Document/File name MODTTT031E.doc	Document Type Internal/External	Revision 1
First Revision, Sign and Date Lan 2006-09-05	Updated Revision, Sign and Date	Document Status and Sign Approved by Bln
Page 1 (5)

Modification to adapt older TTT031 displayunits to the VGX sensor

Componentside of the TTT031 Displayunit

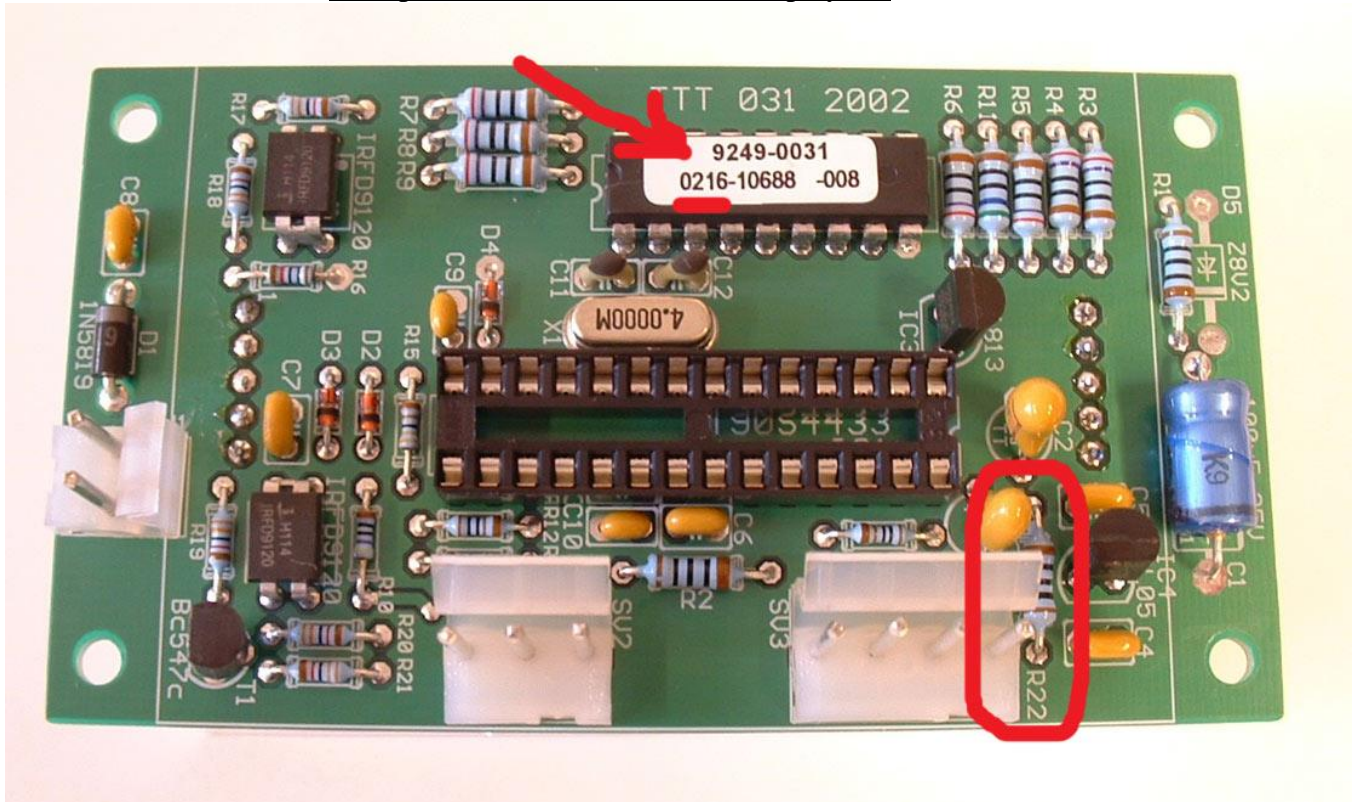
The contactless sensor VGX needs a higher voltage than the older potentiometer. TTT031 display units manufactured before 2006 needs to be modified.

When the unit is manufactured can be checked on the label which is placed on the componentside. The first four digits shows the manufacturing year and week.

- The following example shows manufacturing year is 2002 and week 16. Since this is earlier than 2006 the unit needs to be modified to adapt to the VGX sensor. The modification consists of soldering a 10 ohm resistor parallel to the existing "R22" on the pc board. After the modification the unit can handle both the older potentiometer as well as the VGX contactless sensor.

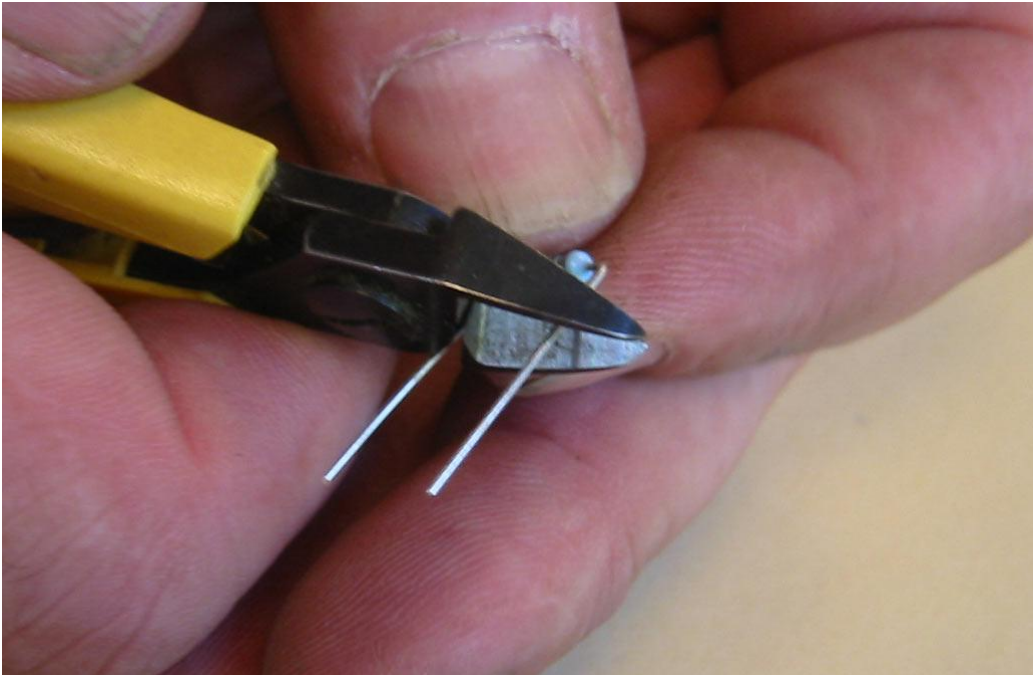
Cut the legs on the resistor and pre-tin!

The legs should be approximately 4 mm each to fit on top of the "R22". Pre-tin the legs to make it easier to solder it onto the board.

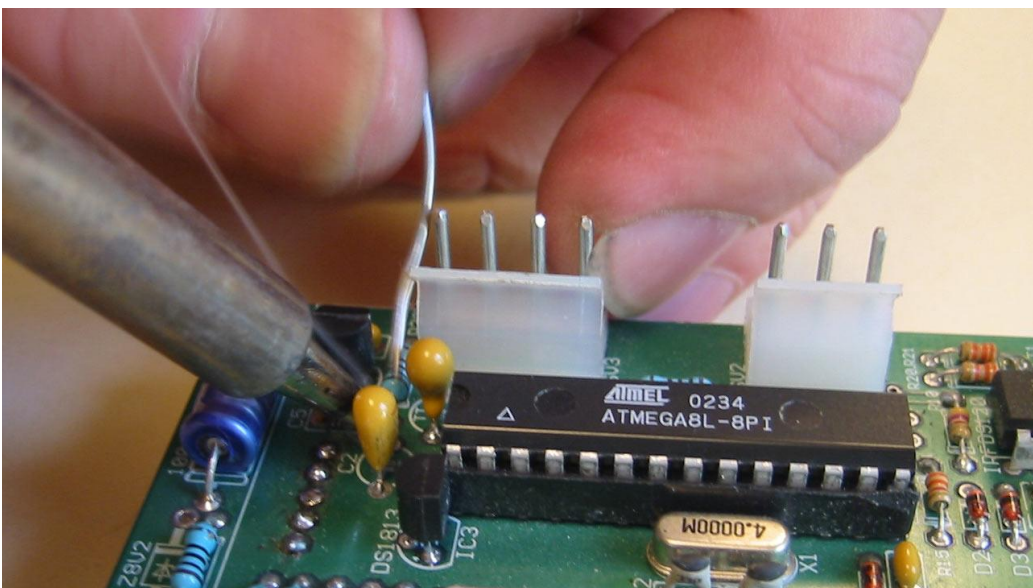
Pre-tin both the legs/solderingpads on the "R22" on the board.

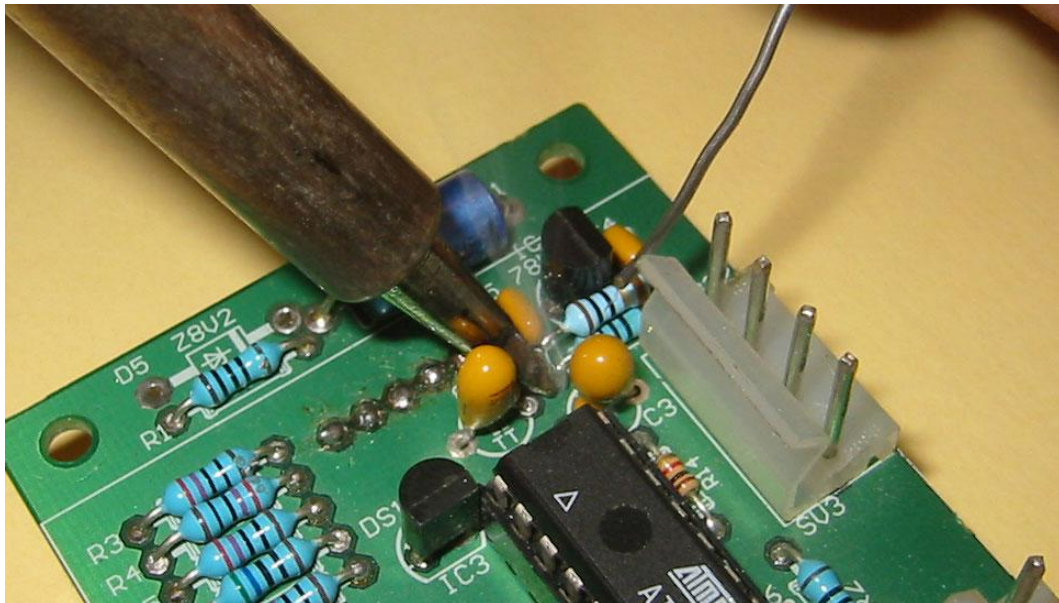
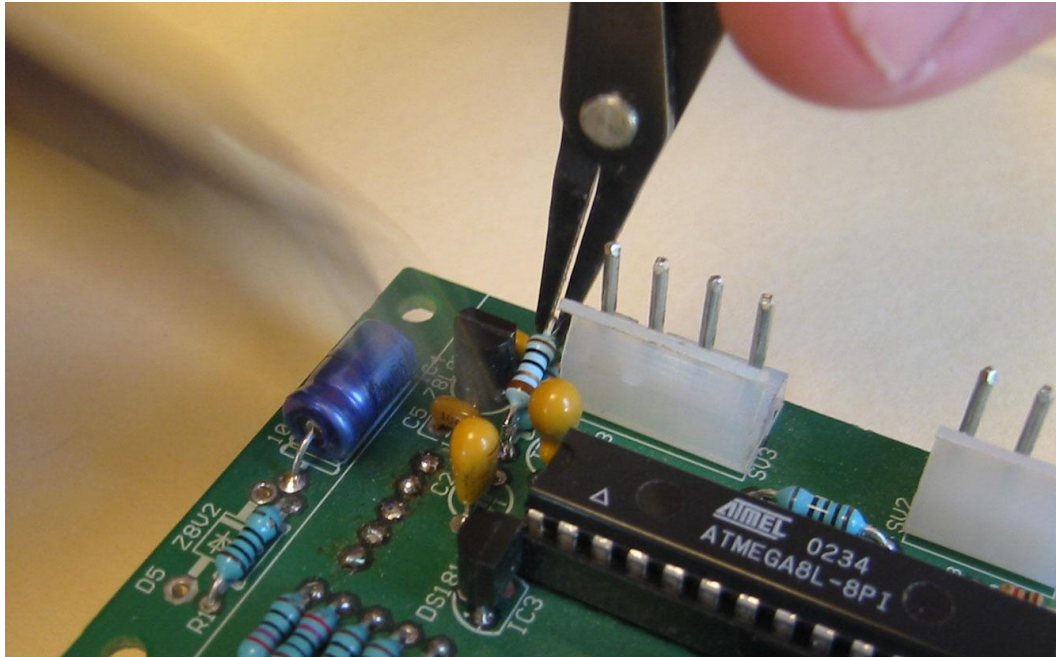
Solder the 10 ohms resistor on top of the R22.

Make sure that you don't damage the nearby components and that you don't heat to much, or to little!!!
